**FINAL REMEDIATION CONSTRUCTION REPORT
ROBESON INDUSTRIES SITE REMEDIATION
CASTILE, NEW YORK**

NYSDEC SITE NO. 9-61-008

**NYS DEPARTMENT OF ENVIRONMENTAL CONSERVATION
DIVISION OF ENVIRONMENTAL REMEDIATION
WORK ASSIGNMENT D003825-6**

OCTOBER 1999

GWET SYSTEM PROCESS FLOW DIAGRAM AS BUILT

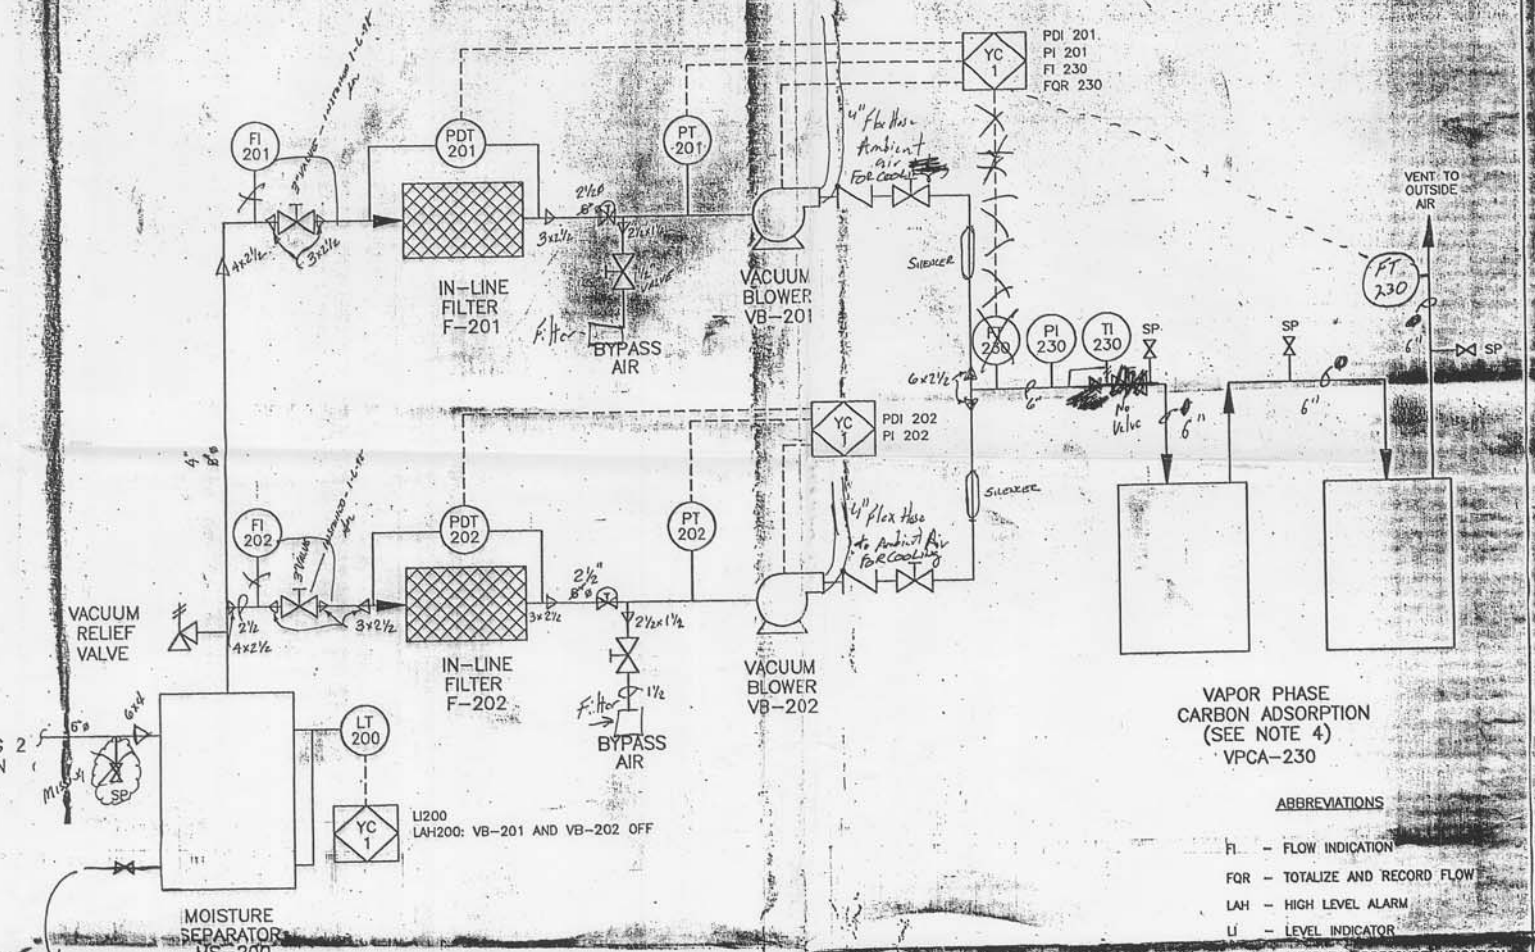
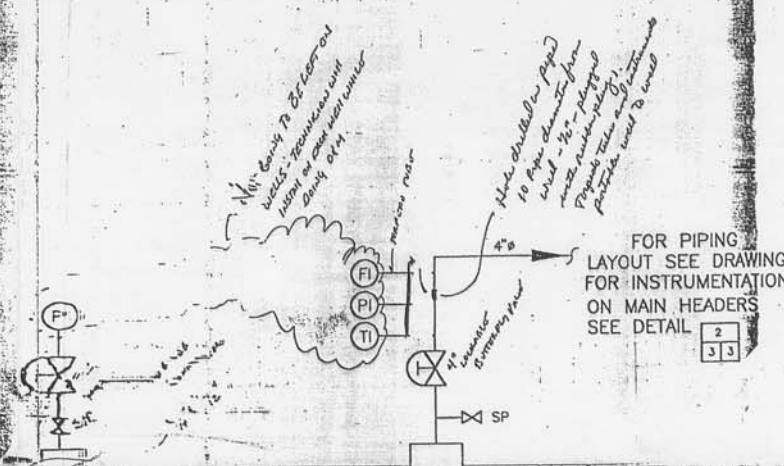
1. The transmitters for measuring the air flow rate in the three header lines were located inside the treatment room for security. The contract drawings show the transmitters located outside the room. (*Variance*)

Transmitters inside of room -
concern to pipe outside of room

SOIL VAPOR EXTRACTION WELL
TYPICAL DETAIL
NOT TO SCALE

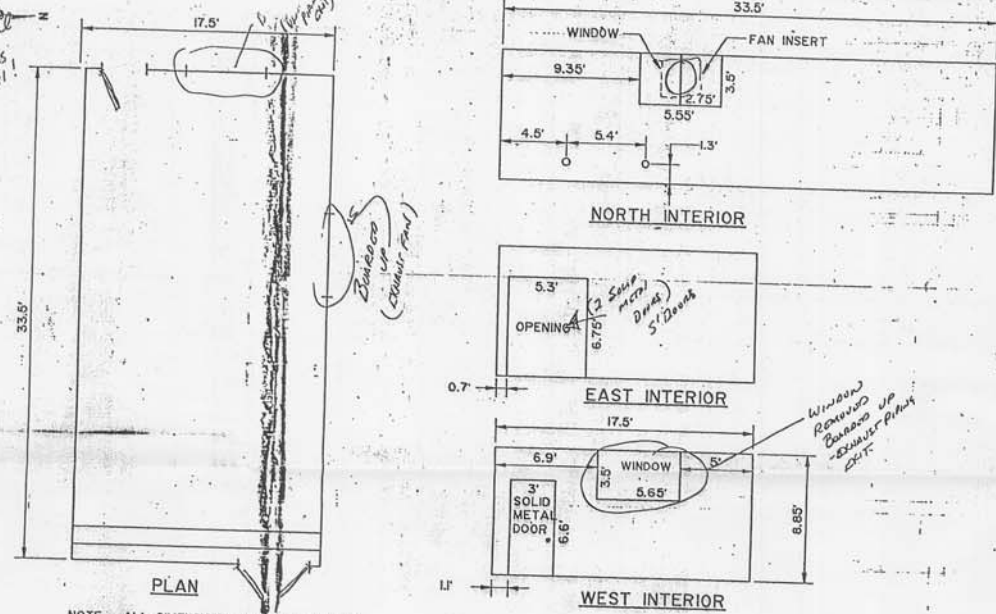
1. All soil vapor extraction wells were installed in the general locations shown on the Contract Drawings. Three of the wells (EX-4, EX-5, and EX-6) shown on Figure 2 are deeper than the 11½-foot depth shown on the drawings. Vapor extraction wells were to be completed at a depth 2 feet above the water table (estimated at 11½-foot bgs). Due to the low water table at the site during well installation, these three wells were installed to an average depth of 15½ feet. (*Change Order No. 3*)

The specifications required that the SVET wells be constructed by drilling until water was encountered and then installing the well to a depth two feet less than the water table. At three of the locations, the total installed depth of the well was deeper than the depths of the wells shown on Contract Drawing No. 5. The total additional depth for the three wells was 12.5 feet.

NOTES:
PVC SCREENING AND RISERS ARE EXISTING FOR ALL EXTRACTION WELLS EXCEPT EX-4, EX-5, AND EX-6. ONLY THE WELL HEAD PIPING AND APPURTENANCES ARE REQUIRED FOR THE EIGHT EXISTING WELLS. EXTRACTION WELLS EX-4, EX-5 AND EX-6 REQUIRE COMPLETE DRILLING AND INSTALLATION.
